## Email and Letter Correspondence Table

**RE: DRAFT St. Catharines GO Transit Station Secondary Plan**

**Re: St. Catharines GO Transit Station Secondary Plan (Draft October 2017)  
Preliminary Comments on Behalf of  
Mountainview Belmont Ridley Heights Inc.  
10 Benfield Drive  
St. Catharines, Ontario  
Our File: BEP/STC/15-01**

# 121-115 St. Paul Crescent

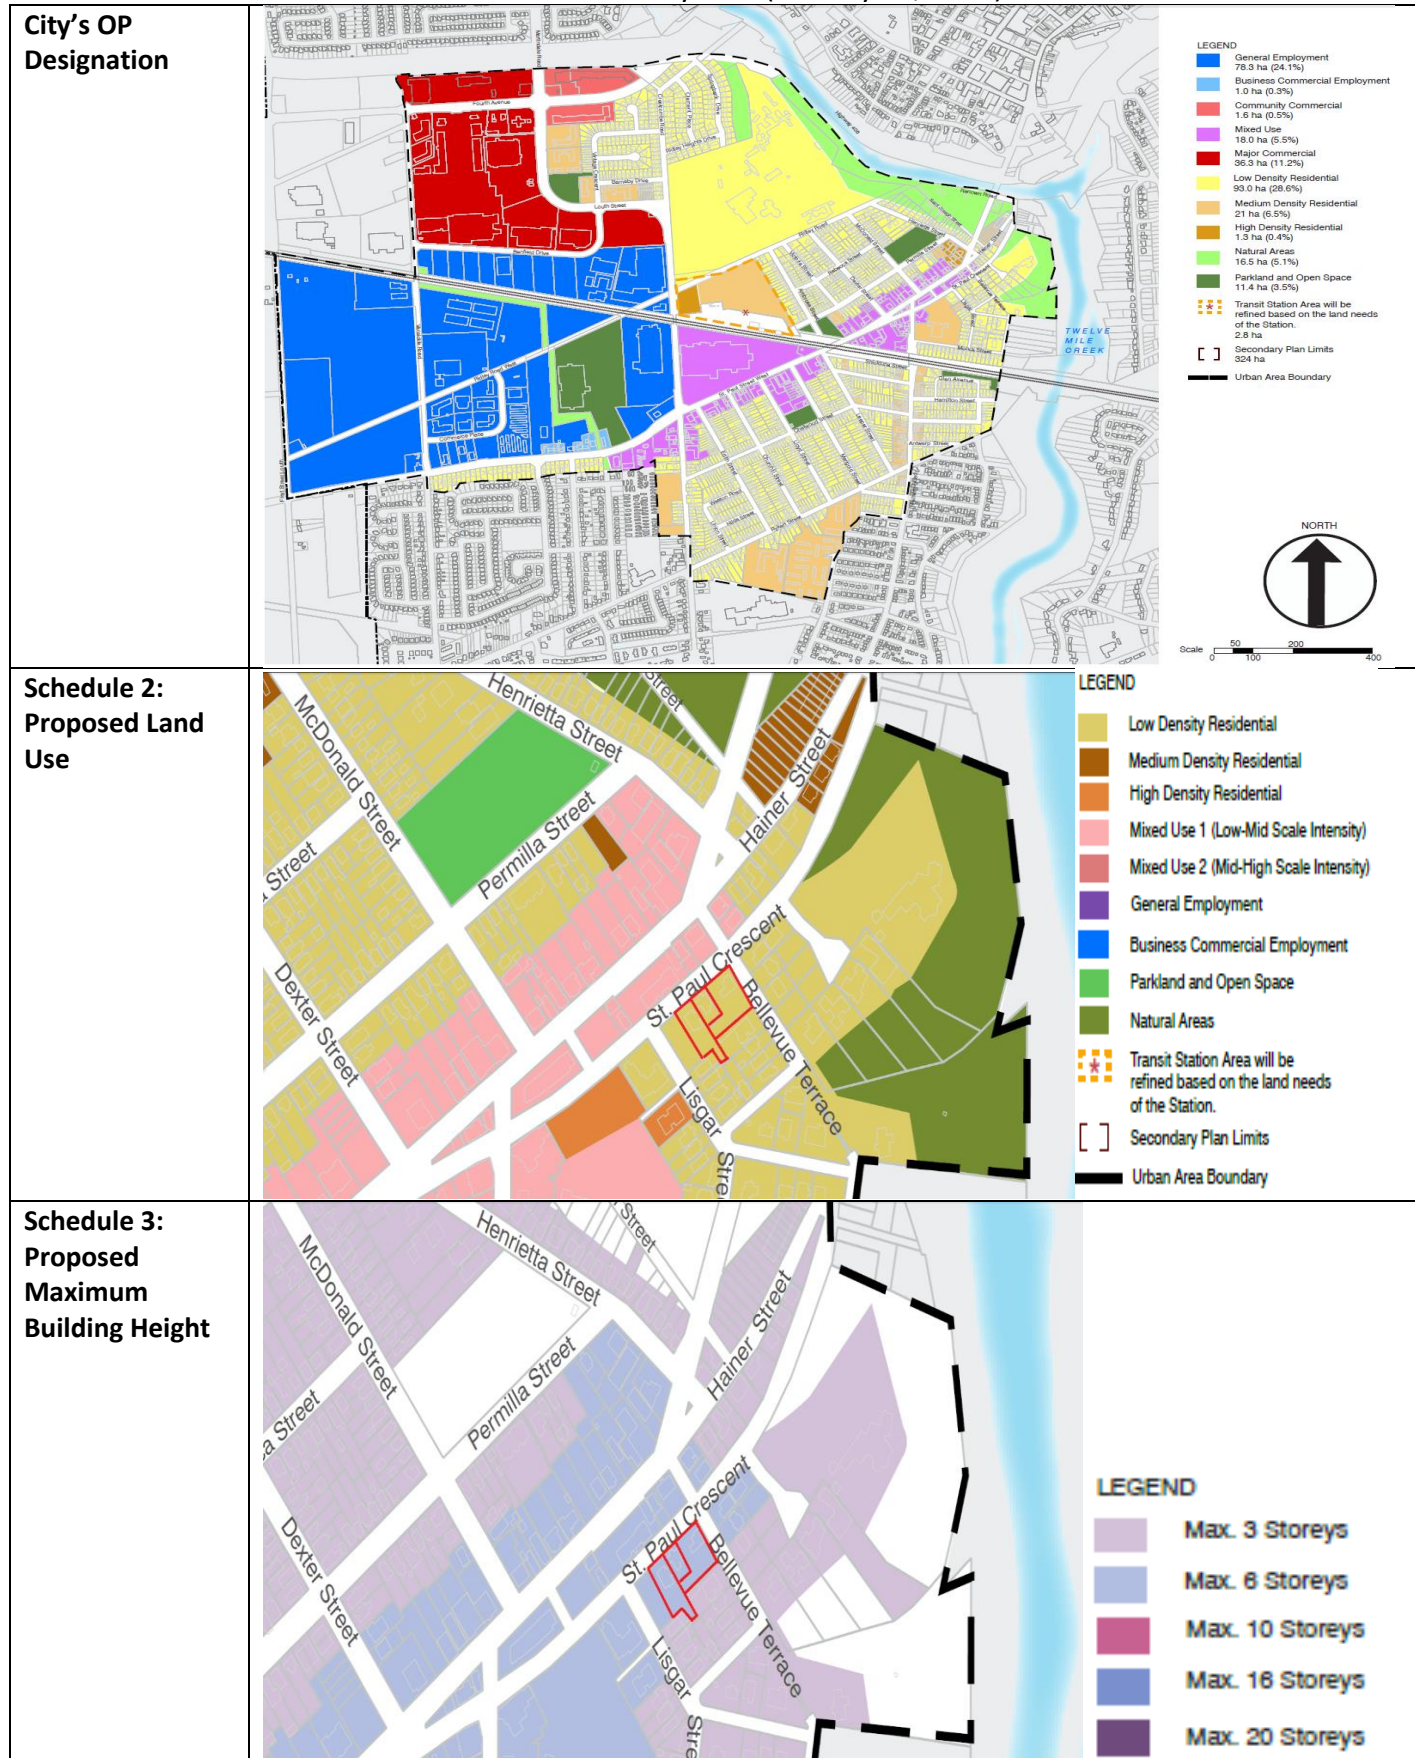
## REQUEST OVERVIEW
